Design Compliance Report – Development Application

Upper Australia Exhibit and Refurbishment of Nocturnal House

Taronga Zoo - Bradley's Head Road Mosman NSW

Report Number & Revision:	MSA2080_BCA_Rev01
Prepared For:	Taronga Zoo
Date of Issue:	24.06.2020

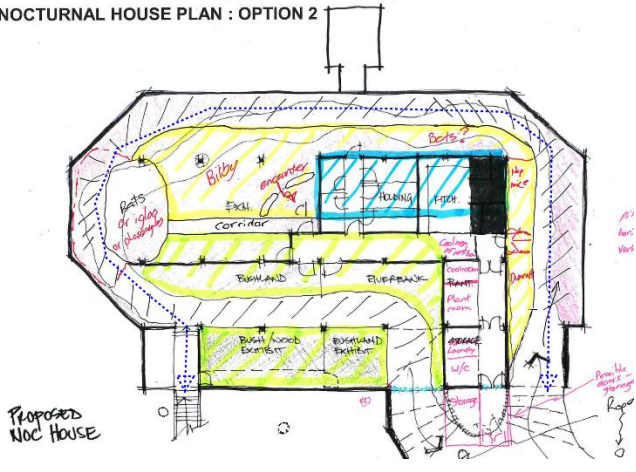
#	DTS Clause	Description of Issue.
1.	D1.4	<p>Exit Travel Distances</p> <p>Egress paths from the staff areas of the Nocturnal House will need to be confirmed/clarified (e.g. Egress from the corridor serving the Bats enclosure –can egress be provided through an enclosure?). A performance solution may need to be provided where travel distances are proposed to exceed the limitations of BCA D1.4.</p> 
2.	D1.5	<p>Distance Between Alternative Exits</p> <p>The distance between the alternative exits in the Nocturnal House (as currently proposed – see blue dotted line in plan extract below) will exceed 60m.</p> <p>A Performance Solution is proposed to address this at Construction Approval Stage.</p>

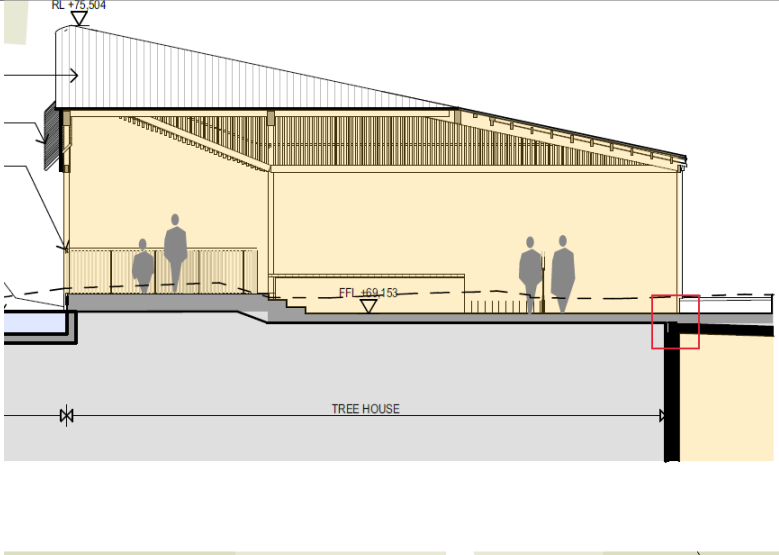
United Buildings	<p>The Treehouse Building appears to sit partially on/over the rear Nocturnal House (which is underground at this point – refer to section extract below). On this basis it is considered appropriate to consider the Treehouse as being part of the Nocturnal House.</p>

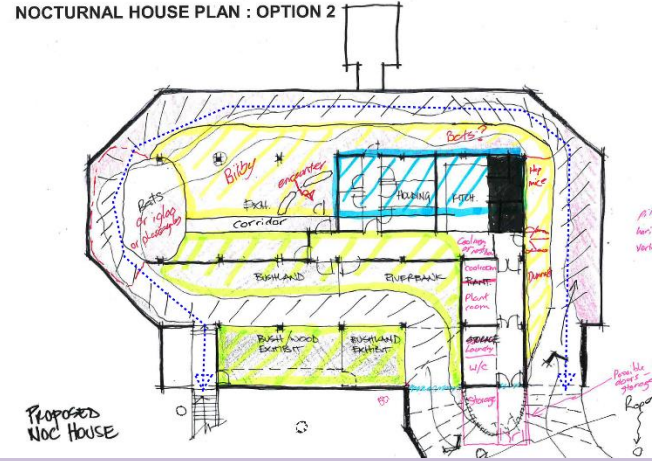
D1.4 Exit Travel Distances	<ul style="list-style-type: none"> Class 2 & 3 buildings <ul style="list-style-type: none"> The distance between the entrance door of a Sole Occupancy Unit (SOU) and an exit or Point of Choice (POC) to 2 alternative exits must not exceed 6m (20m on ground floor) From all parts not in a SOU – 20m to exit or POC Class 4 buildings – entrance door of SOU to exit or POC must not exceed 6m Class 5, 6, 7, 8 or 9 buildings – 20m to exit or POC <p>Additional requirements apply to Class 9 buildings, and open Spectator stands</p>	Egress paths from the staff areas of the Nocturnal House will need to be confirmed/clarified (e.g. Egress from the corridor serving the Bats enclosure –can egress be provided through an enclosure?). A performance solution may need to be provided where travel distances are proposed to exceed the limitations of BCA D1.4.
